**MINUTES  
CITY OF LAKEWOOD  
BOARD OF BUILDING STANDARDS/  
ARCHITECTURAL BOARD OF REVIEW/SIGN REVIEW  
REVIEW MEETING  
NOVEMBER 12, 2020  
5:30 P.M.  
VIRTUAL MEETING**

## Architectural Board of Review

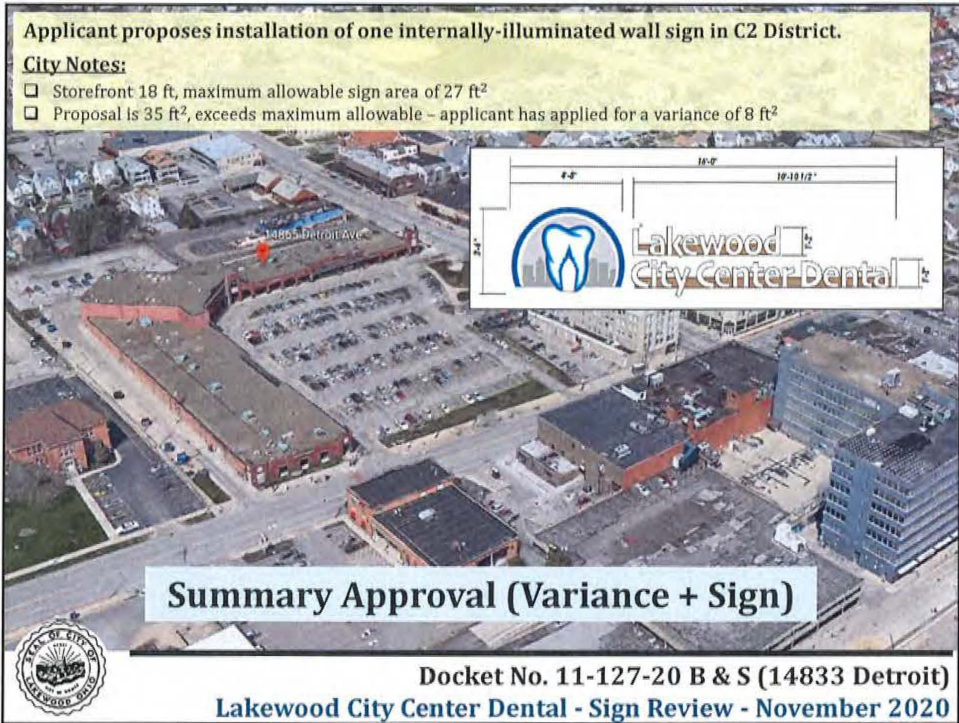
Applicant proposes installation of one internally-illuminated wall sign in C2 District and requests a variance to 1329.09 (c)(1) – maximum sign face area.

- Storefront 18 ft, maximum allowable sign area of 27 ft<sup>2</sup>
- Updated following October feedback (reduce size to fit within parapet lines)
- Using "smallest rectangle" method (1329.04, Measurement Standards), proposal measures ~23 ft<sup>2</sup>
- No longer requires a sign face area variance.

**Docket No. 09-87-20 (1382 Gladys)  
Front Porch Renovation - ABR - November 2020**

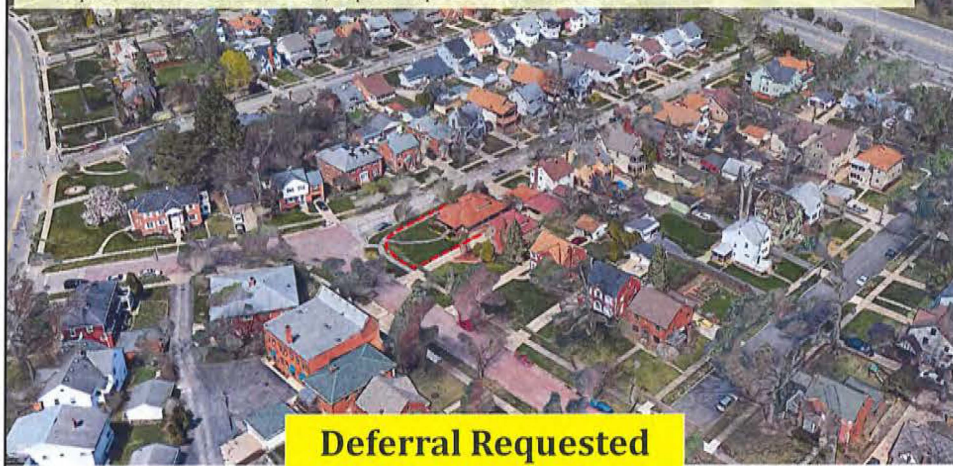
- Correction notice issued on 20 July 2020 for work with no permit.
- Plans submitted 5 Aug - received plan approval from Building Department 21 Aug, conditional on ABR
- Renovation intended to match adjacent home porch (1378 Gladys)

Staff stated the applicant requested a deferral.

**Docket No. 11-113-20 (2063 Belle)**  
**Front Portico Renovation - ABR - November 2020**

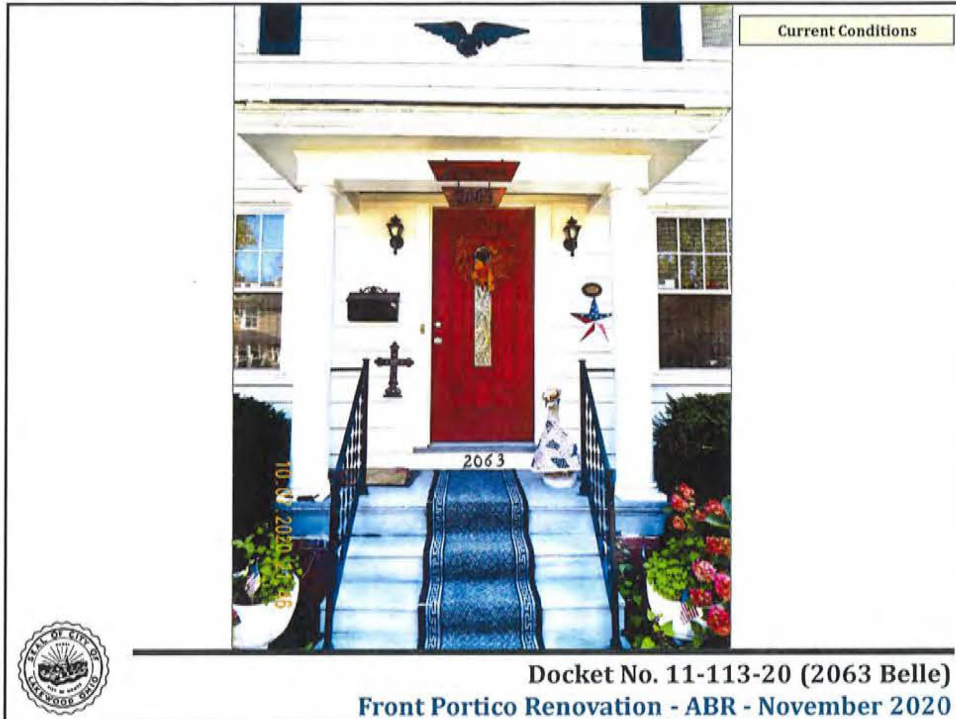
Jason Booth, High Noon Remodeling, applicant and Chris Shaw, Designer were present to explain the request. Discussion ensued about where the peak of the gable would be in relationship to the second-floor windows. The members liked the design, asked if lattice would infill the space under the steps,

asked if the deck was deeper than the existing brick pier. Staff supported the submission. Staff advised the applicant that the plans would be approved by the Division of Housing and Building (“H&B”) on Friday, November 13<sup>th</sup>. Public comment was closed as no one addressed the item. Staff had not received any comments or chats.

- Lattice will infill the area under the stairs to the pier.

1455 Orchard Grove Ave

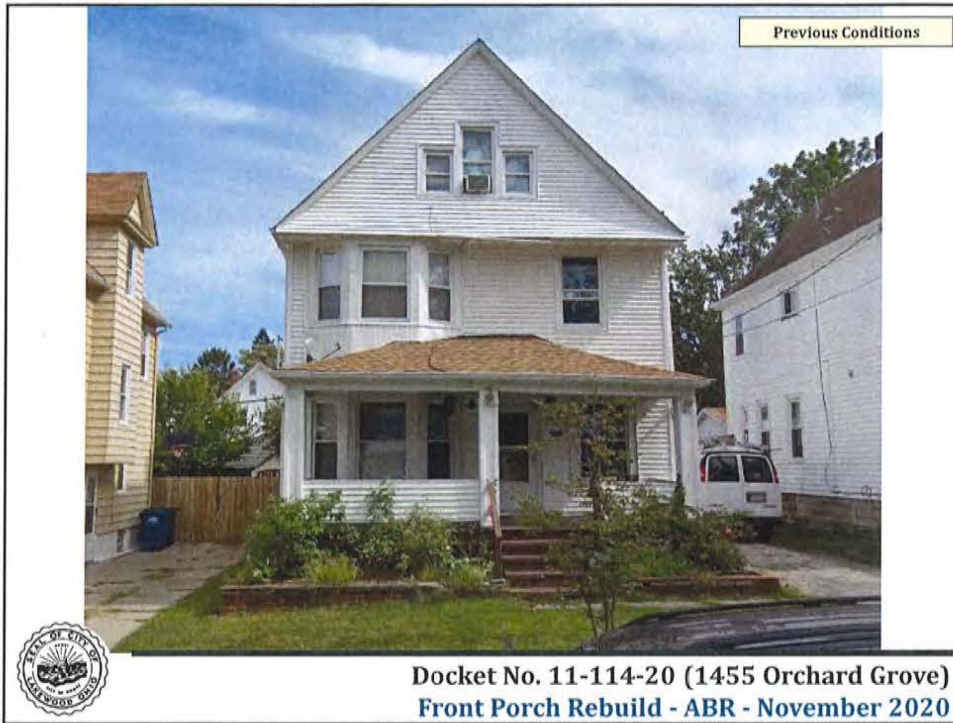
Staff provided a brief introduction. Yamneh Abdelhady, applicant and Mr. Rohost (spelling), carpenter were present to explain the request. The members asked if railings would be on both sides of the steps, confirmed the porch railings conformed to the guidelines, said the spindles should be on the inside, asked about the colors and piers. Staff had no further comments. Public comment was closed as no one addressed the item. Staff had not received any comments or chats.

- Provided/discussed porch guidelines (railing detail)
- Confirm intended finish colors.

- The spindles would be on the inside of the railings.

**Docket No. 11-115-20 (1315 Chase)  
 Front Porch Rebuild - ABR - November 2020**

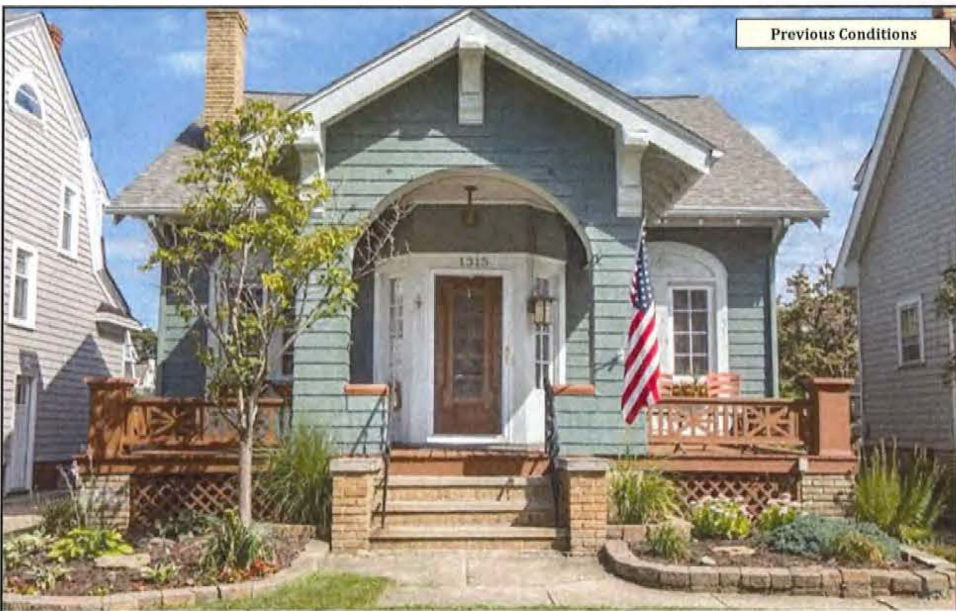
Staff provided a brief introduction. Chuck Dobrzeniecki, representative for the applicant, was present to explain the request. The members had encouraged the applicant to pay attention to the wingwalls and railing. The members liked the proposal. Staff had no comments. Staff relayed communication of support (made part of record). Public comment was closed as no one addressed the item.

**City Notes:**  
 Applicant provided updated front elevation sketch to reflect pre-review recommendations

**Docket No. 11-117-20 (17820 Cannon)**  
**Front Porch Renovation - ABR - November 2020**

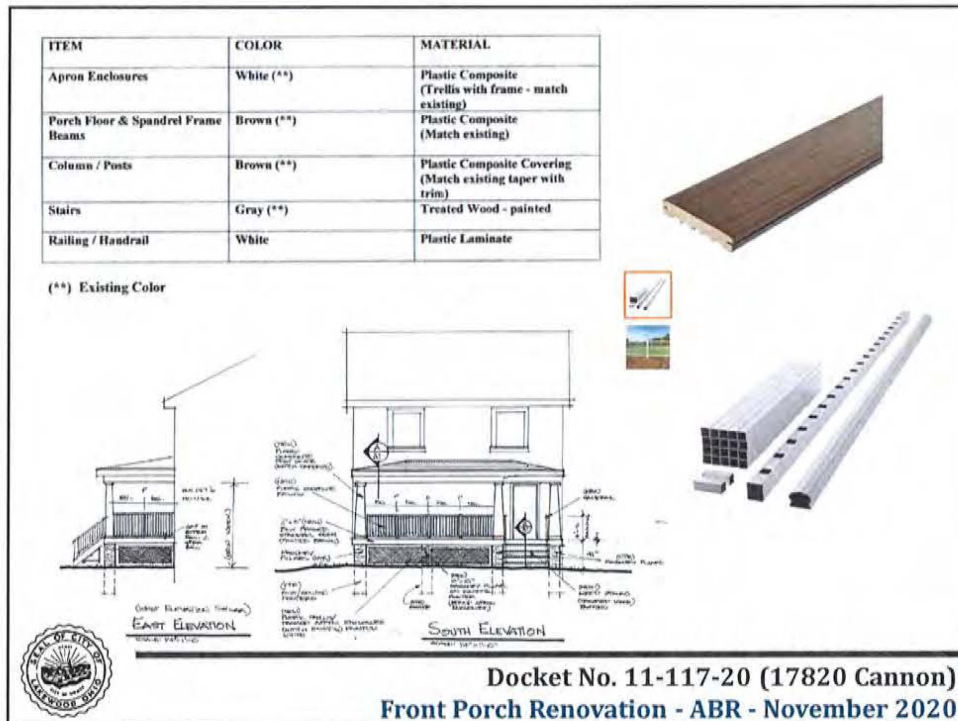
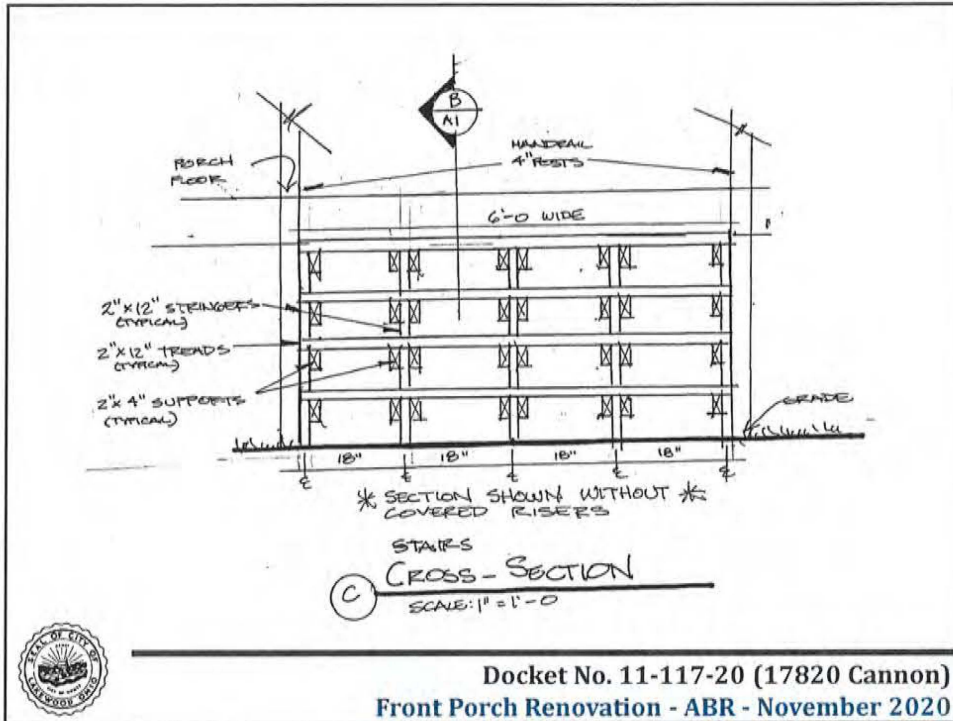
Staff provided a brief introduction. Greg Noeth, Greg Noeth Architect, applicant was present to explain the request. The members liked the proposal. The members asked if the porch roof was sagging; the applicant said it was not a structural problem. Staff said the cause of the sag could not be confirmed without exposing the porch ceiling. The applicant stated he could fix the problem easily. Staff appreciated the detail and clarity of the drawing. Public comment was closed as no one addressed the item. Staff had not received any comments or chats.

- The applicant works with staff and homeowner for repair of the header to straighten the fascia of the porch roof.

Docket No. 11-119-20 (13369 Madison)  
Storefront Renovation - ABR - November 2020

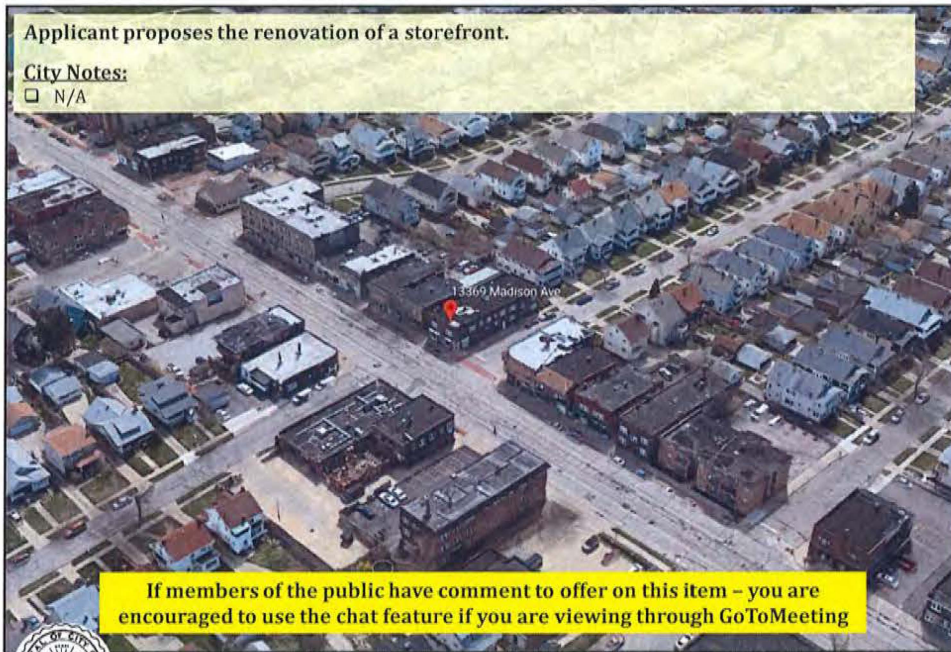
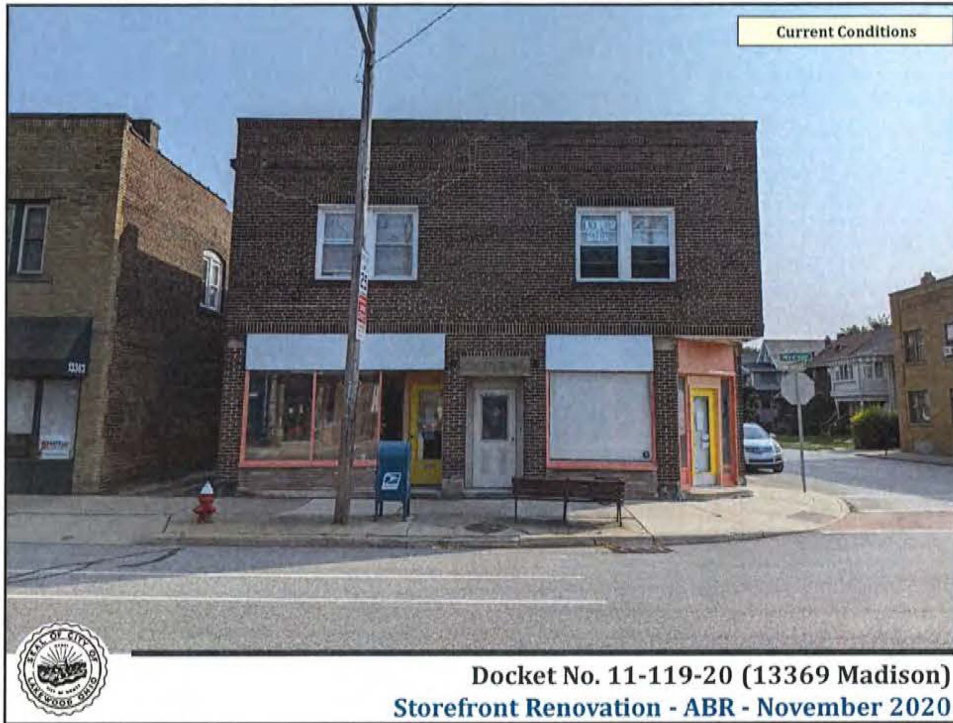
David Maniet, Maniet Architects, applicant was present to explain the request. the members asked about paint colors, lighting, suggested painting the center door black, etc. The members liked the proposal. Staff asked if the brick would be painted. Public comment was closed as no one addressed the item. Staff had not received any comments or chats.

- The center door is painted black.

**Docket No. 11-120-20 (16300 - 16400 Detroit)  
Trinity Church - ABR - November 2020**

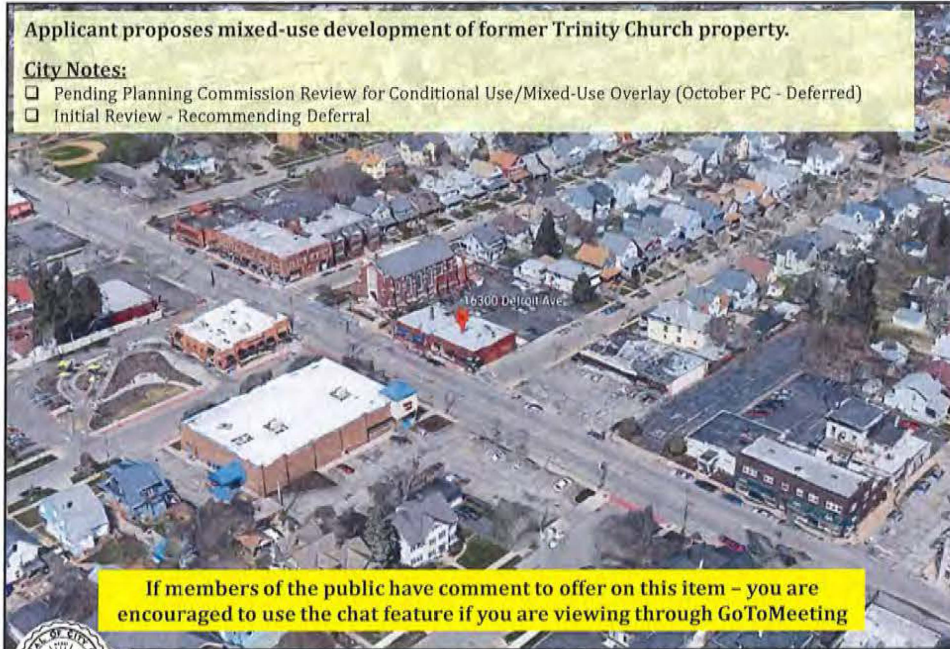
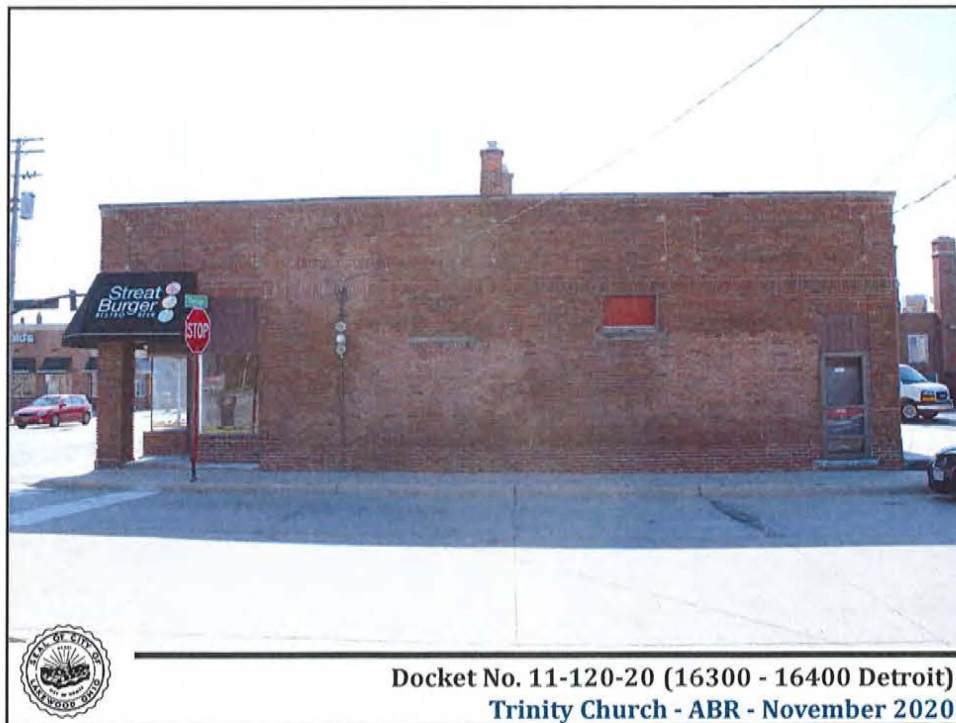
Staff provided an introduction, expressed concerns, and stated additional information was required. John Holtz, Dimit Architects, applicant was present to explain the request. The members noted there were several issues with the parking lot/spaces/traffic flow. Discussion continued about the proposed carriage house. The members liked the all brick exterior, stated the bays were not in proportion to the other

- Pending Planning Commission Review for Conditional Use/Mixed-Use Overlay (October PC - Deferred)
- Initial Review - Recommending Deferral

A motion was made by Ms. Haney, seconded by Mr. Waddell to **DEFER** the request. All the members voting yea, the motion passed.

**Docket No. 11-121-20 (16817 Madison)  
Wall Repair/Railing Installation - ABR - November 2020**

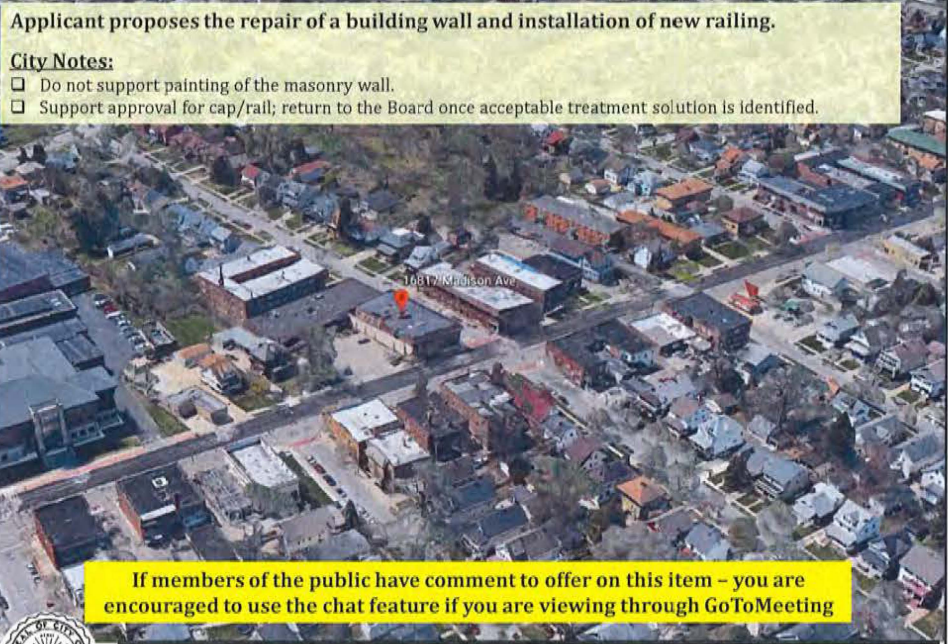
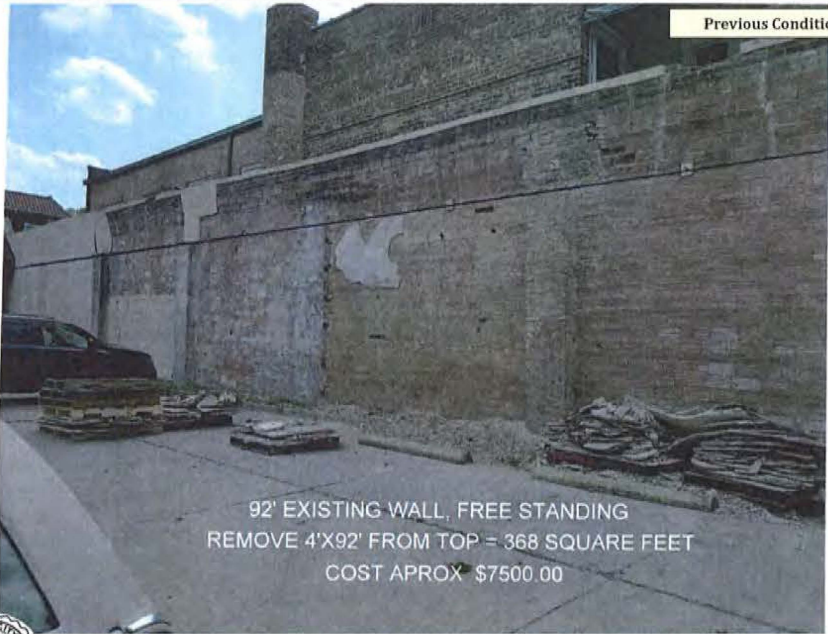
Staff provided an introduction, did not support painting of the masonry wall. Gregory Schnupps, applicant was present to explain the request. The members liked the railing and cap. The members said the wall was not to be painted; if any work were proposed for the wall, the applicant would have to return. Public comment was closed as no one addressed the item. Staff received three written comments (made part of record), there were no chats.

- Do not support painting of the masonry wall.
- Support approval for cap/rail; return to the Board once acceptable treatment solution is identified.

- Any work on the exterior wall would require the applicant to return to the Architectural Board of Review for approval.

**Docket No. 11-129-20 (12906 Madison)  
Barroco - Sign Review - November 2020**

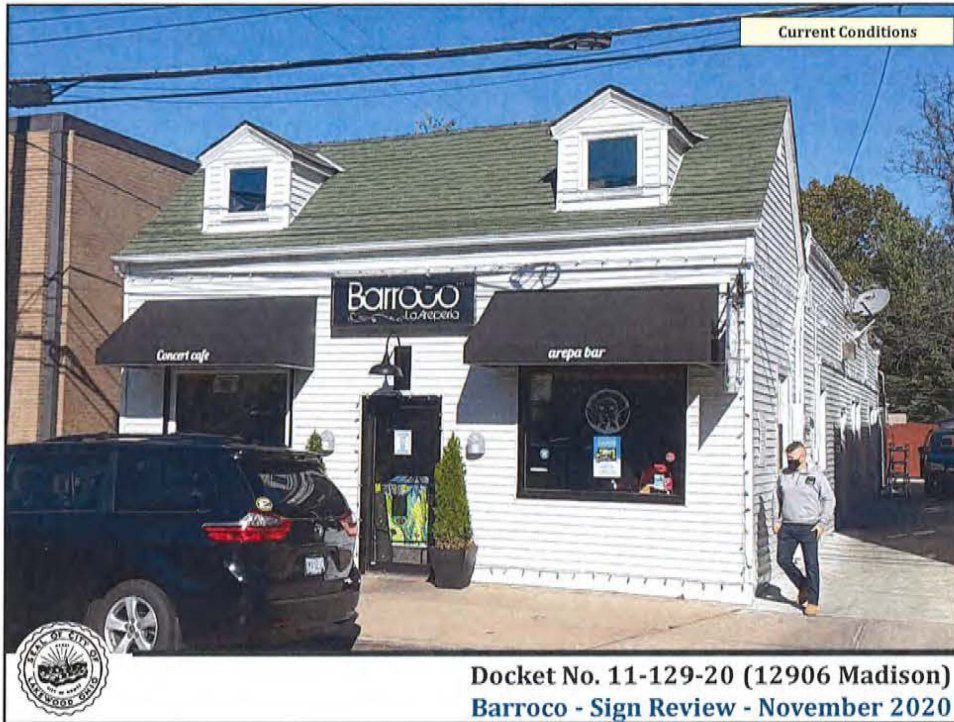
Staff provided a brief introduction. Steven Foster, The Sign & Graphics Firm was present to explain the request. The members asked if the blade sign and awnings would remain, asked about the branding, and confirmed the illumination. The members liked the proposal. Public comment was closed as no one addressed the item. Staff had not received any comments or chats.

- Storefront 28 ft, maximum allowable sign area of 42 ft<sup>2</sup>
- Proposal replaces existing wall sign with ~30 ft<sup>2</sup> added to remaining 10 ft<sup>2</sup> of other approved signage.
- While mounted to roof, classified as wall sign – does not meet second condition (“completely over the roof”)

- The steel tube framing is painted to match the roof color.
